Product Service Group CE Audio

Service Information

CHANGES DURING PRODUCTION

COMBI BOARD

CIRCUIT DIAGRAM - POWER SUPPLY PART

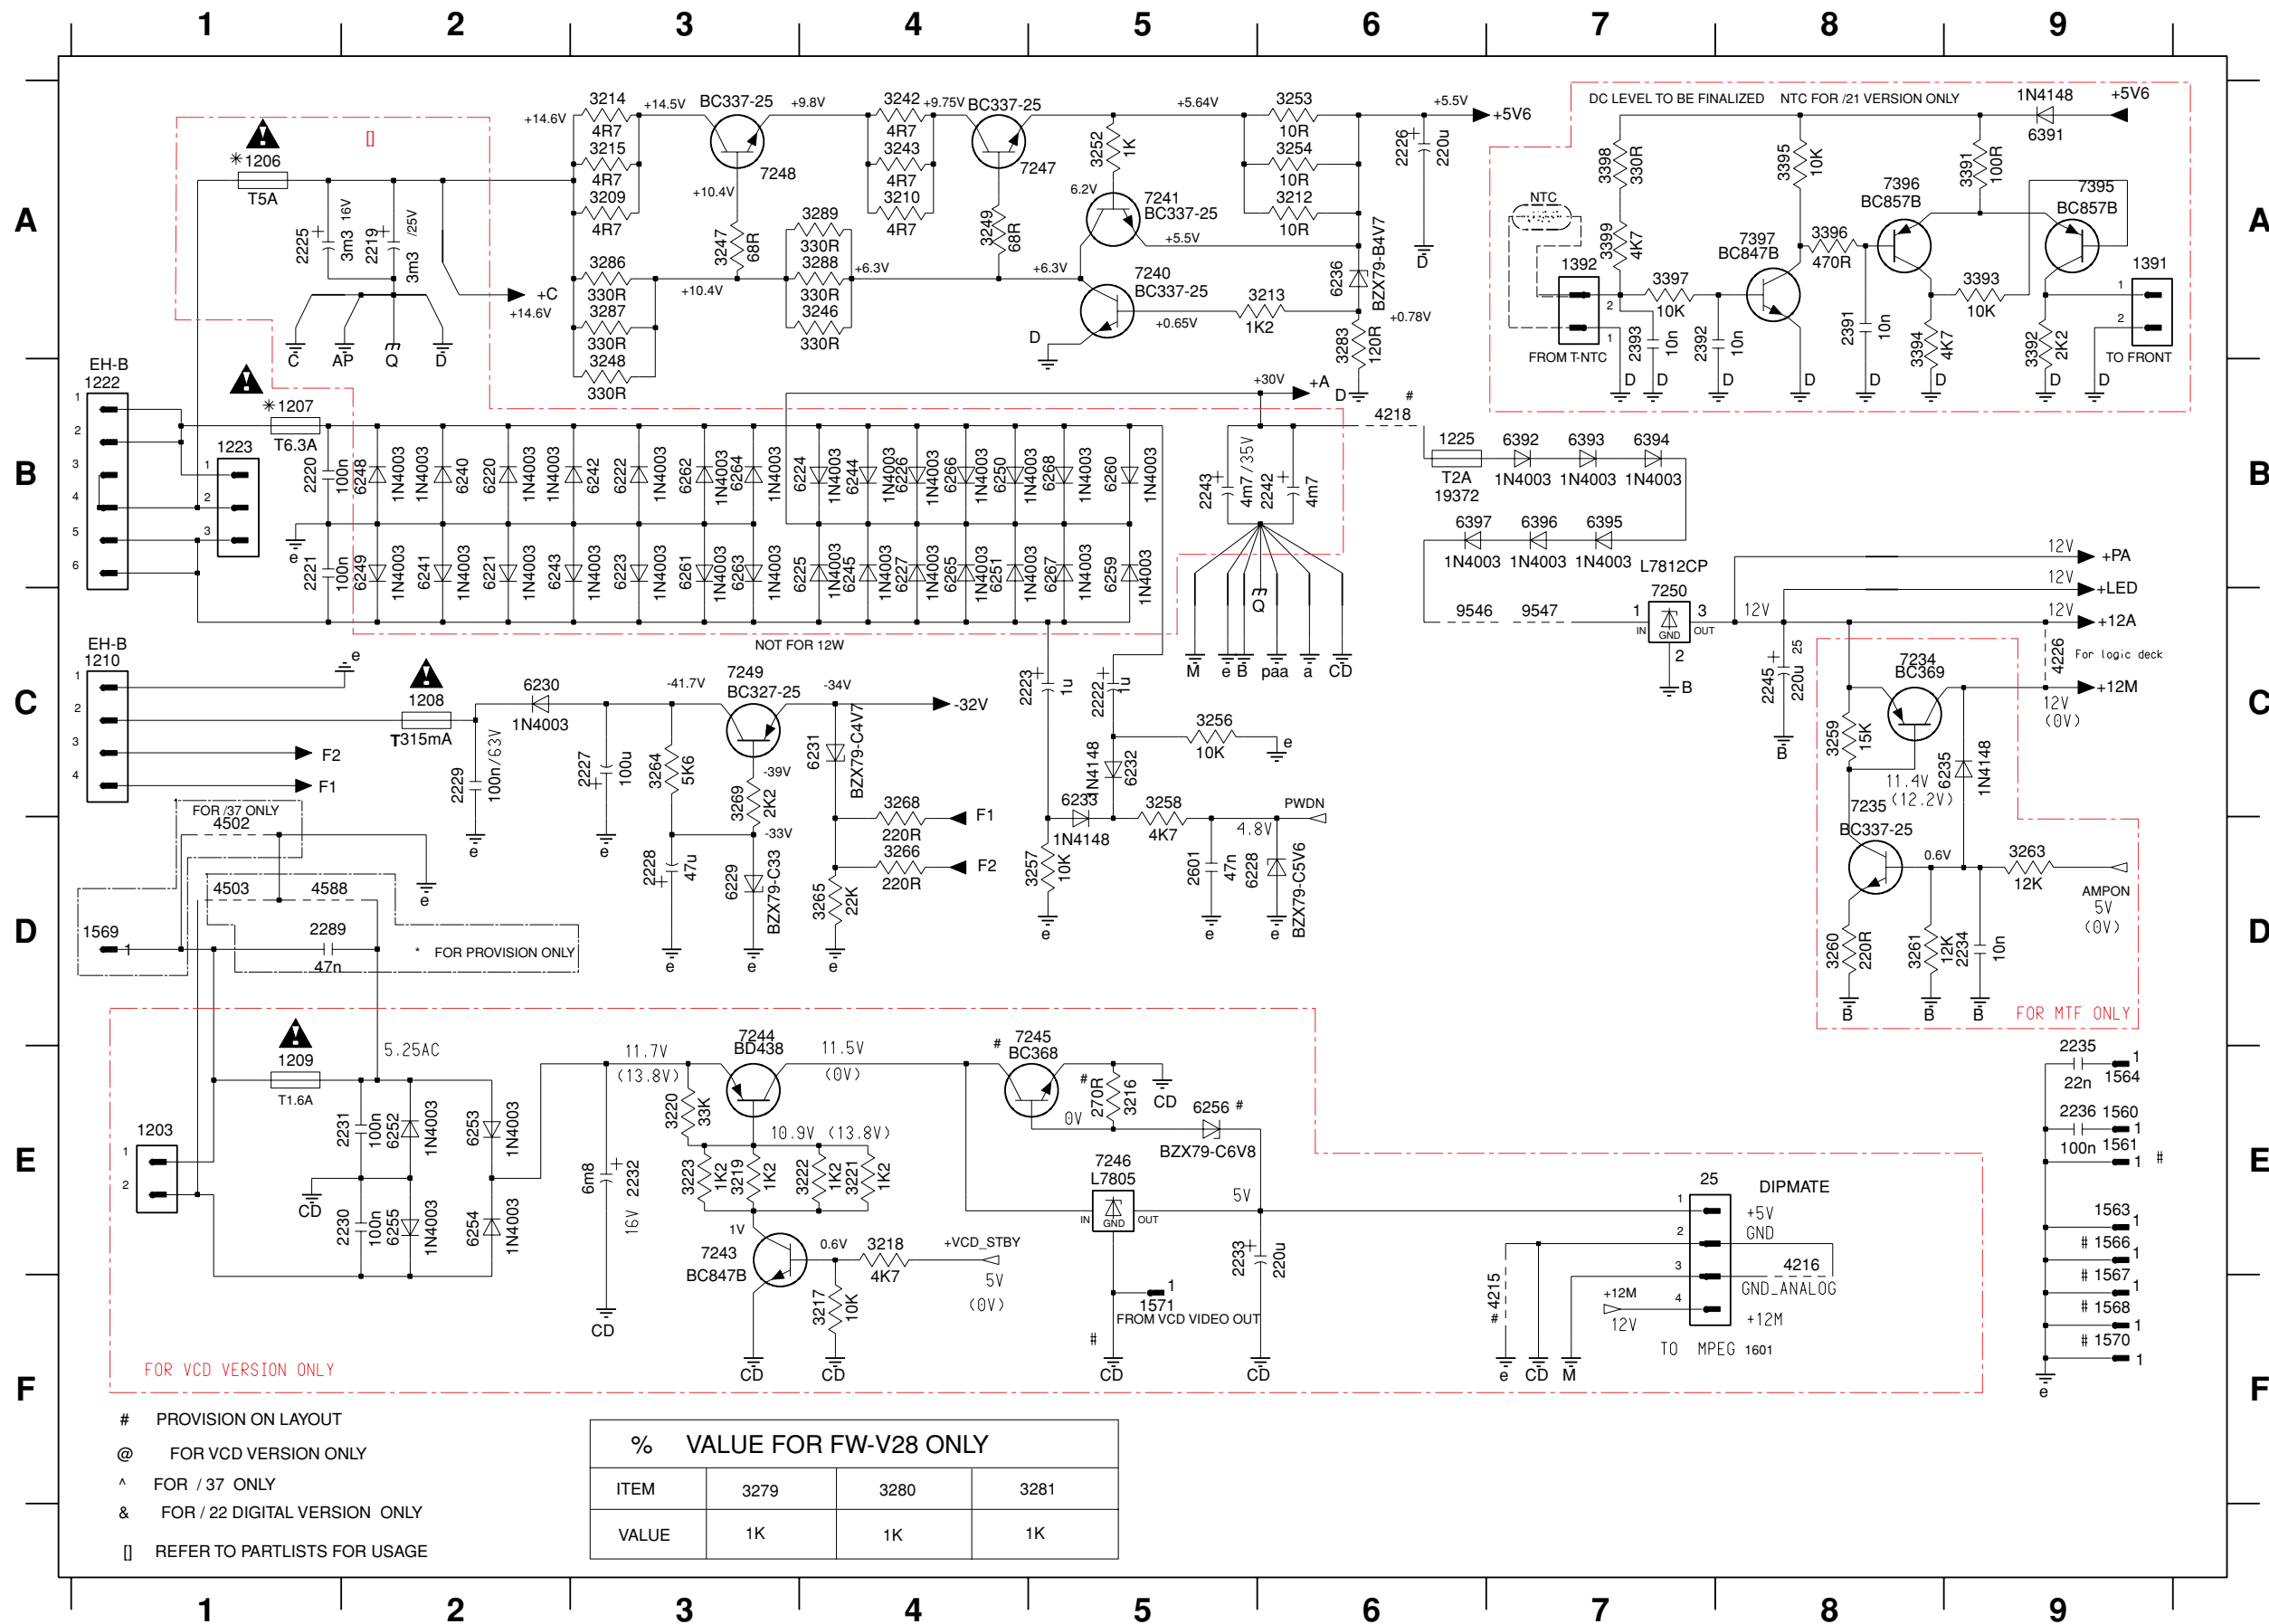
* From production wk212 (for FW-C252/21 Brazil KITS only) onwards a new pt. 5 board (recognized by marking 3139_113_34115_01) was introduced to solve transistor 7233 (BD242BFP) failure causing 12V supplier line to increased to 30V

Delete:

2224, 2246, 2247, 3270 - 3282, 4217, 4221, 4288,
4571, 6257, 6258, 6269, 7233 and 7236 - 7239

Add:

1225	9965 000 07788	△ Fuse T2A 250V
2601	4822 121 43526	47nF 10% 50V
4218	4822 051 20008	0R Jumper 0805
4681	4822 051 20008	0R Jumper 0805
4682	4822 051 20008	0R Jumper 0805
6392	4822 130 31878	1N4003
6393	4822 130 31878	1N4003
6394	4822 130 31878	1N4003
6395	4822 130 31878	1N4003
6396	4822 130 31878	1N4003
6397	4822 130 31878	1N4003
7250	4822 209 33575	L7812CP

Due to this design change the new schematics and layout drawings are enclosed.
